DRAWN	A. G.	DATE	04/2/84	TITLE	SCHEMATIC - SPEECH & SOUND CARTRIDGE
CHECK		DATE			
DESIGN	J. M. Pickett	DATE	6/18/84		
APP'D	J. M. Pickett	DATE	6/18/84		
APP'D	[Signature]	DATE	6/18/84		
DWG NO	D-8000227	SIZE	D		
SCALE	NONE	SHEET	1	OF	1

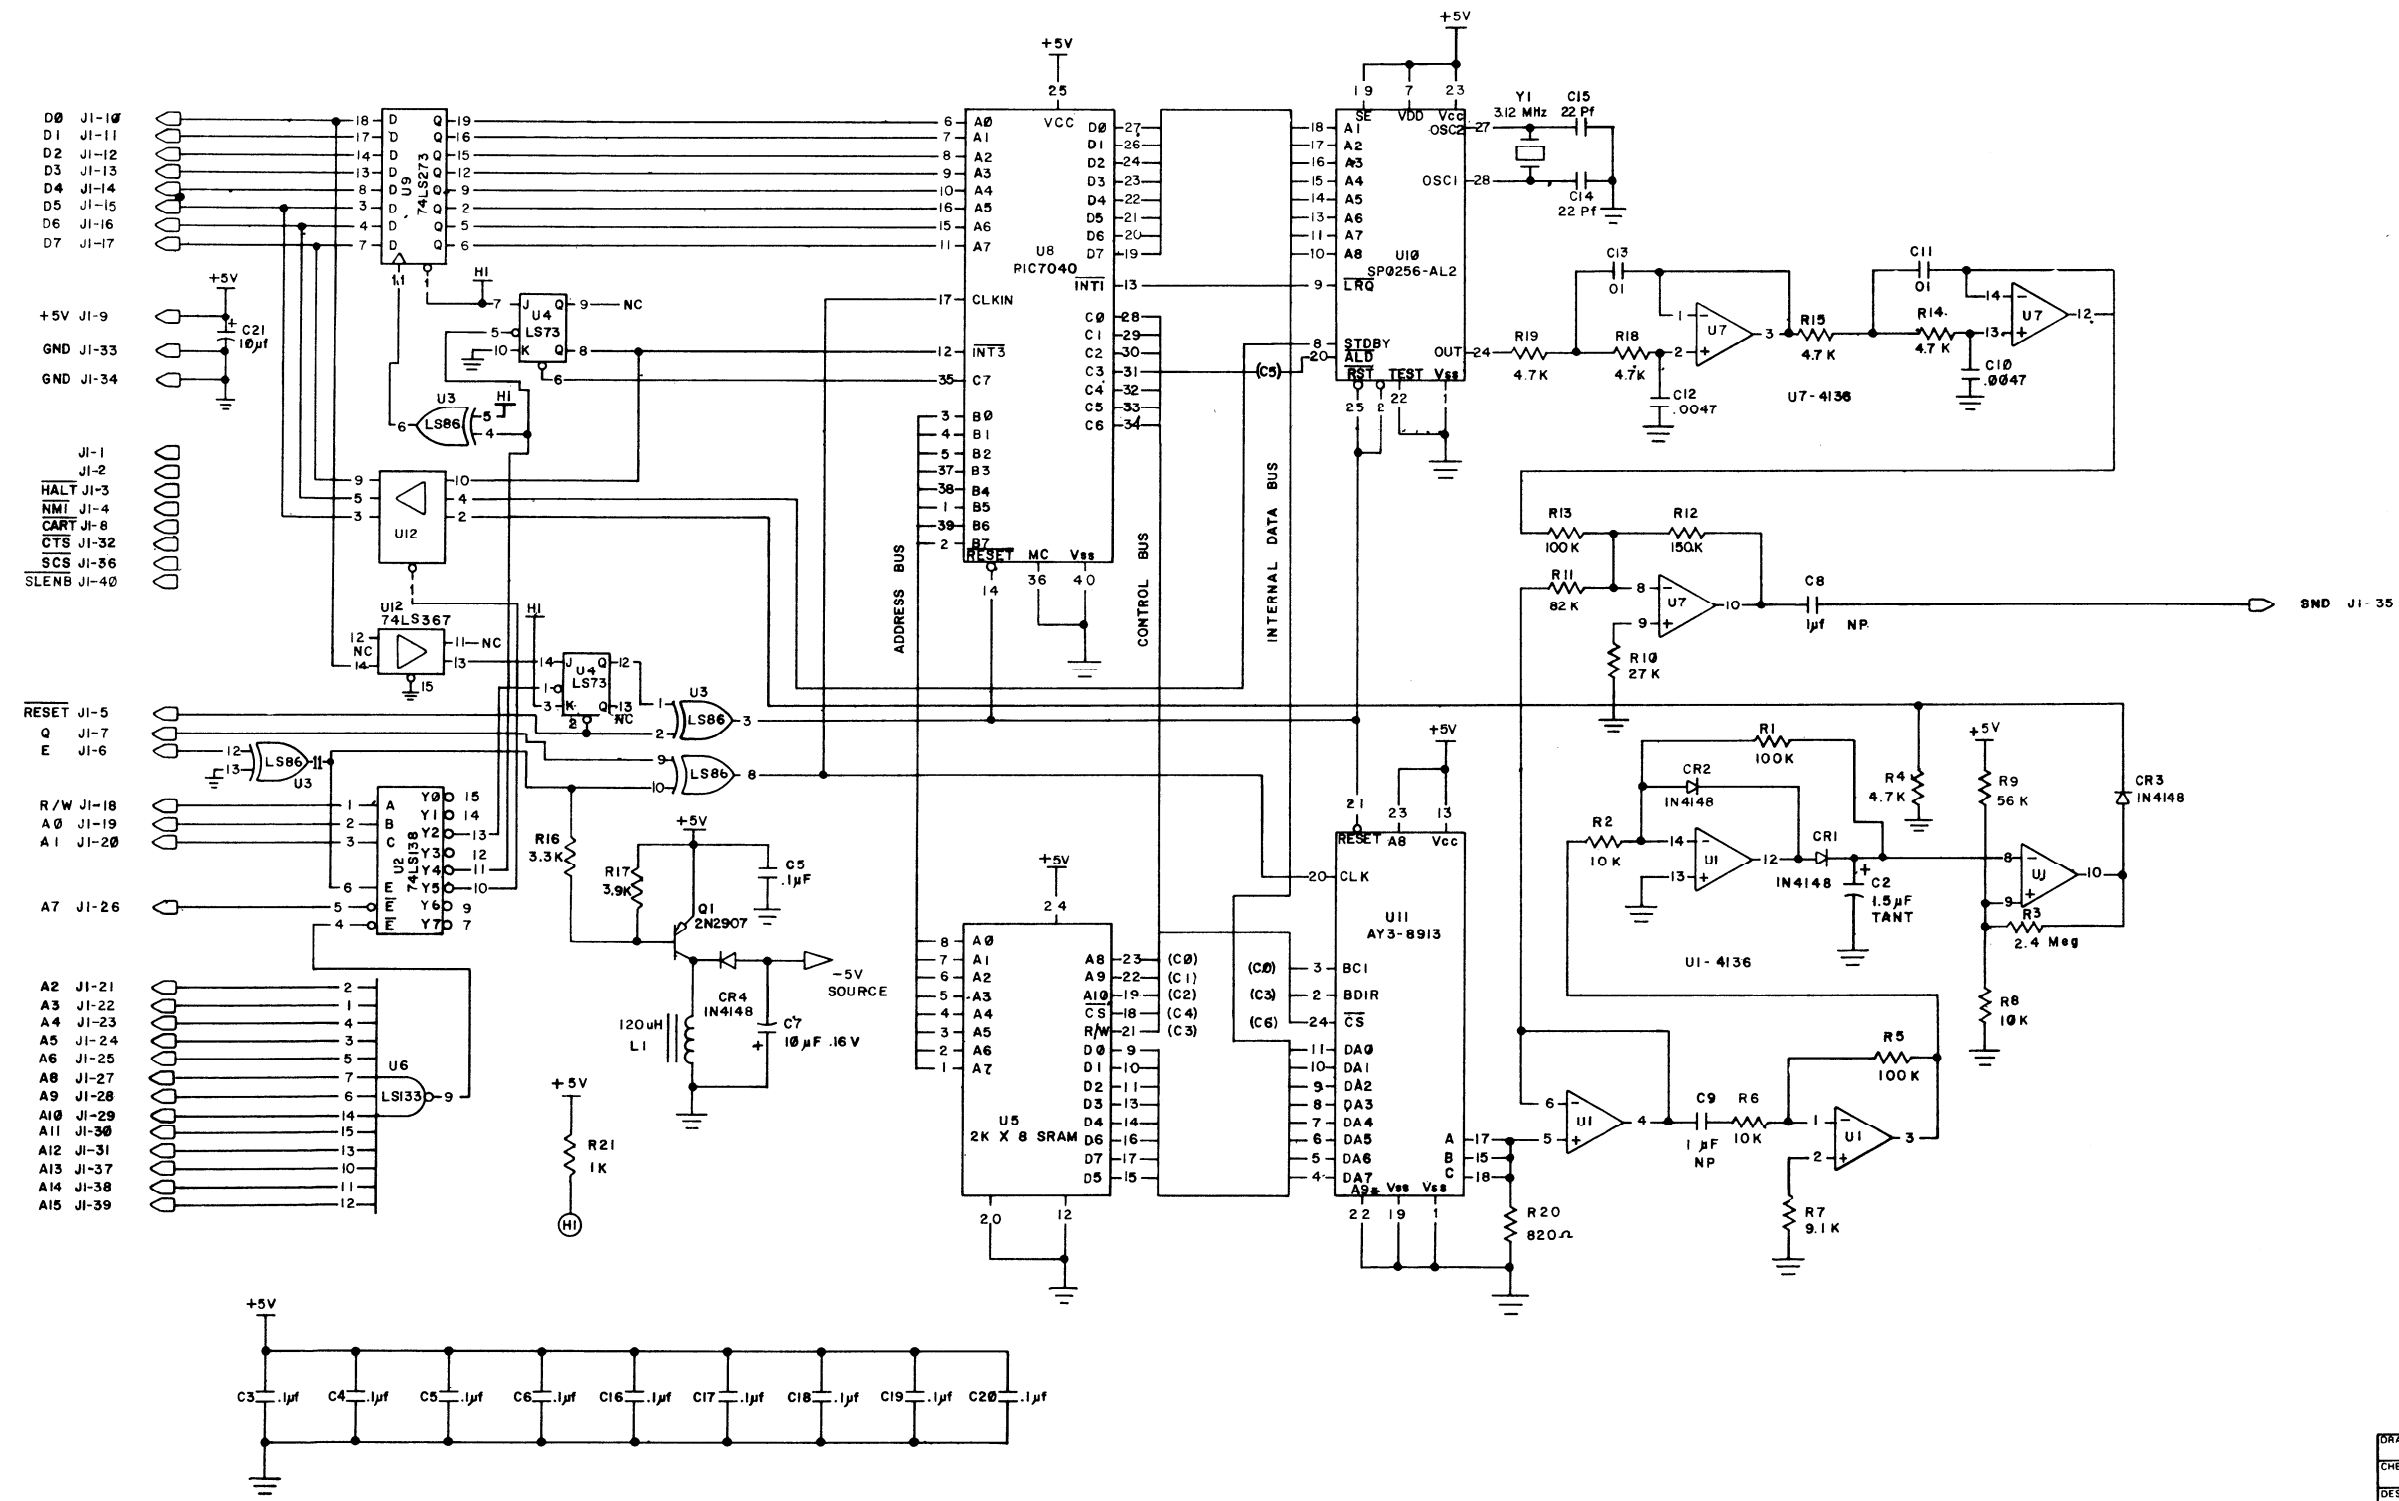
ZONE	LTR	REVISION		DATE	APPROVED
		DESCRIPTION			
A		U1 WAS M1 (CORRECTED ERROR); C15 WAS C13 (DUPLICATE); ADDED .1μF X 9 CAPS		6/12/84	[Signature]
		RELEASED FOR PRODUCTION		6/18/84
